Pentium® Processor Specification Update

Release Date: January 1998

Order Number: 242480-034

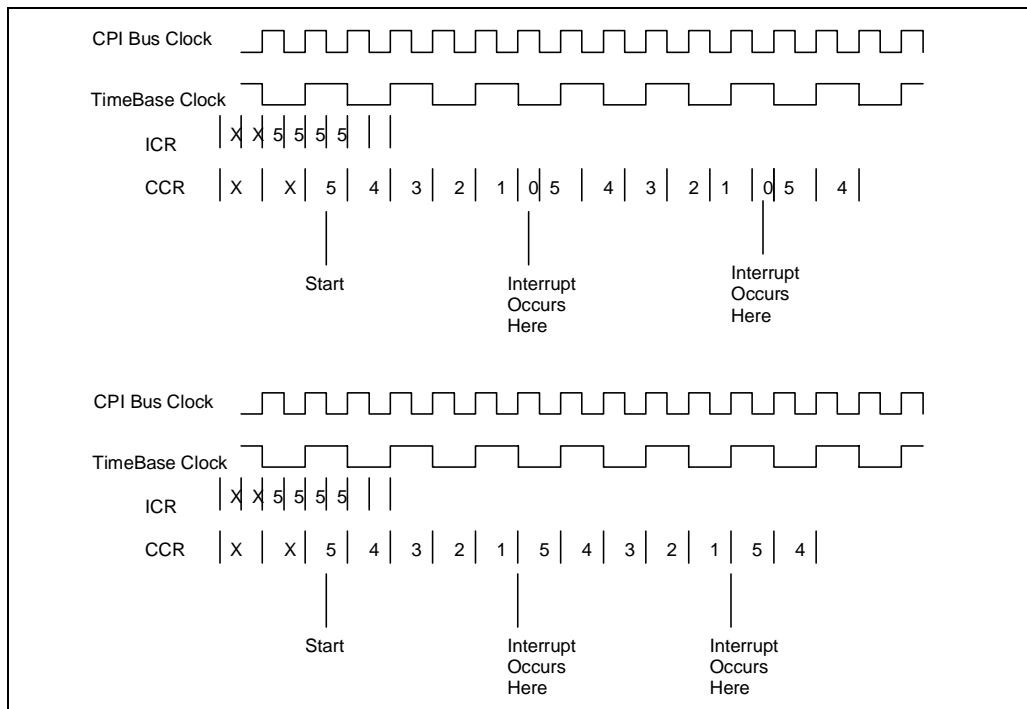
The following pseudo-code shows the generic algorithm for waking up Pentium processors, including 82489DX based systems, dual processor systems and multi-processor systems. The algorithm will work with future processors too.

Figure14-1. Maximum Undershoot Level, Undershoot Threshold Level, and Undershoot Threshold Duration

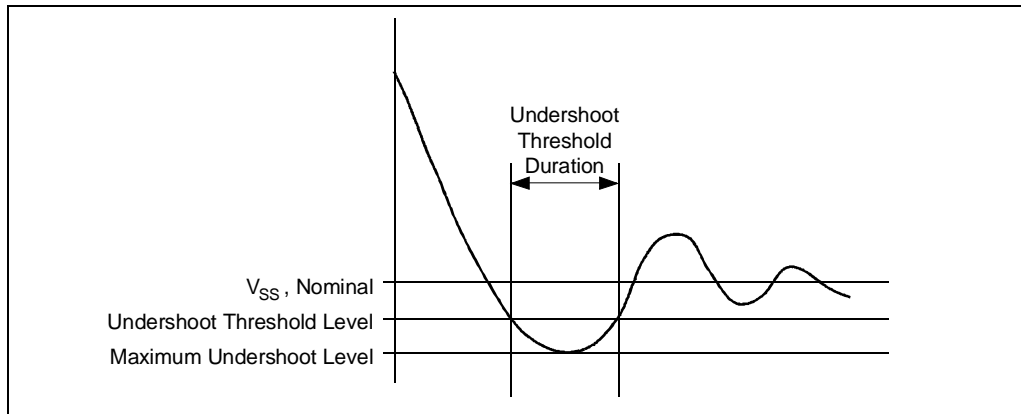
MAXIMUM RINGBACK SPECIFICATION: The maximum ringback of CLK associated with its low state (undershoot) must not exceed 0.8V as shown in Figure 14-1.

MAXIMUM UNDERSHOOT AND MAXIMUM RINGBACK SPECIFICATIONS: The display should show continuous sampling (e.g., infinite persistence) of the waveform at 500 mV/div and 5 ns/div (for CLK) for a recommended duration of approximately five seconds. Adjust the vertical position to measure the maximum undershoot and associated ringback. There is no allowance for crossing the maximum undershoot or maximum ringback specifications.

UNDERSHOOT THRESHOLD DURATION SPECIFICATION: A snapshot of the clock signal should be taken at 500 mV/div and 500 pS/div (for CLK). Adjust the vertical position and horizontal offset position to view the threshold duration. The undershoot threshold duration is defined as the sum of all time during which the clock signal is below -0.5V within a single clock period. The undershoot threshold duration must not exceed 20% of the period.

This undershoot specifications are illustrated graphically in Figure 14-1 and Figure 14-2.
